Westgate Kemps Creek

SSD-23480429

Water and Stormwater Management Plan

2. Response to Submission - Stormwater

Figure 11: Stage 1 Post-development MUSIC model layout

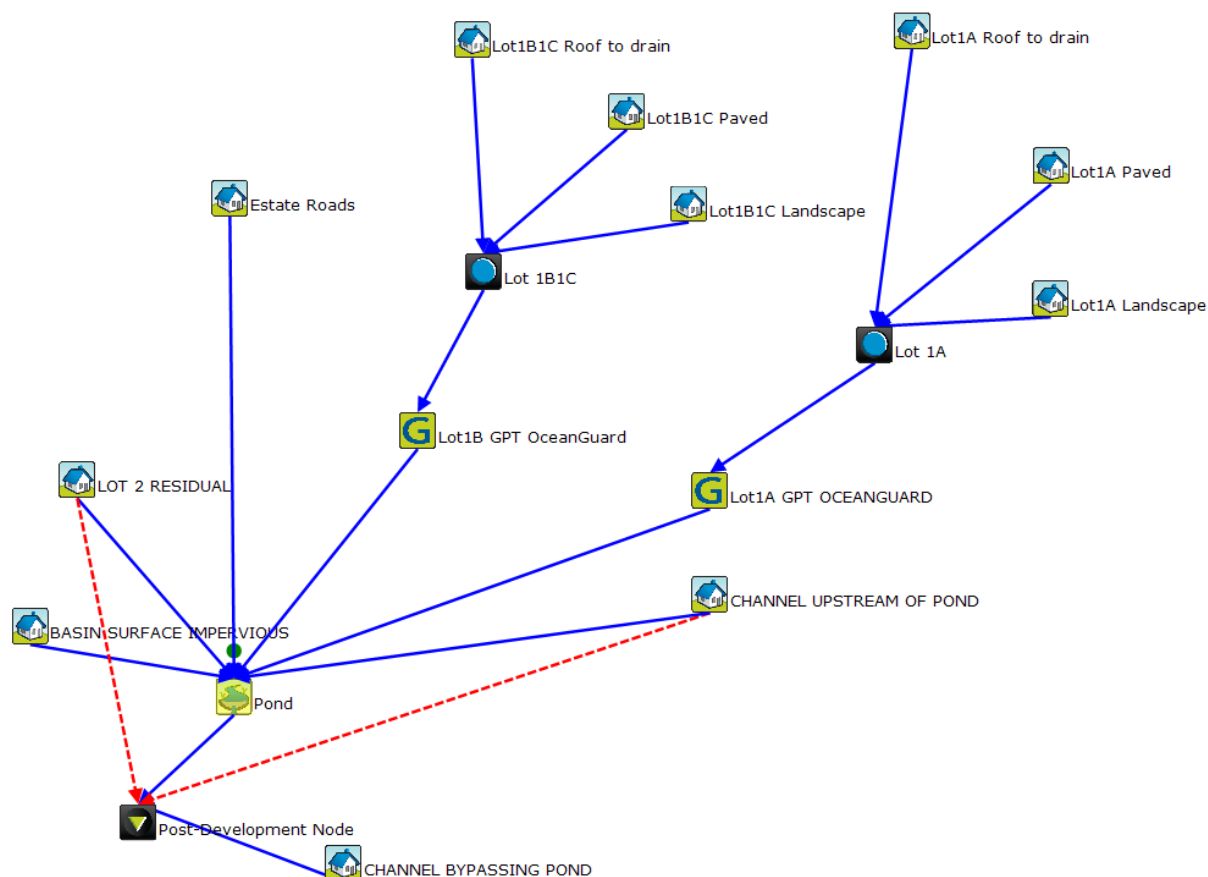
RTS Comment	Response
Biodiversity, Conservation and Science (DCCEE)	
1) The MUSIC model was not submitted and has therefore not been reviewed. The report and plans contain a number of treatment devices (Humefilter, Jellyfish filter) that do not have any of the modelling assumptions stated.	MUSICX model has been provided in the package. Modelling assumptions shown in the report in further detail in Section 8.2 .

The post-development (Interim Arrangement/ Stage 1) model has been created based upon the proposed post-development catchment extents presented in **Section 5.2**. Source nodes for each of the proposed lots have been adopted based on the *Technical Guidelines for Achieving Wianamatta South Creek Stormwater Management Targets* (DPE, 2022). The layout of the post-development scenario in MUSIC is presented in **Figure 10** above.
